Minerals Inspection Report

Mine Name: Diamond Mountain Resources	Permit Number: M/47/0066	Mine Status: Active
Operator Name: Deseret Generation and Transmission	Inspection Date: 6/16/2015	Permit Fees: Paid
Inspector(s): A. Abate	Inspection Time: 2:00 PM	Bond Amount: \$275,000
Attendee(s): B. Dickson, D. Herron	Weather: Thunder storms	Bond Escalation: 03/17/2015
Inspection Purpose: Routine inspection		Prior Inspection: 10/14/2014

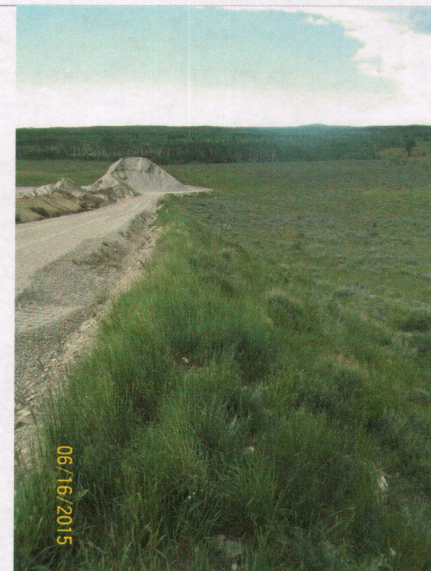
Topsoil pile was partially vegetated.

Sediment Pond 1 located at the southwest corner of the mine was dry.

Sediment pond 2 located southeast of the mine appeared to be at capacity.

The outslopes of the berms around the perimeter of the disturbance areas were nicely vegetated and function well in terms of controlling erosion.
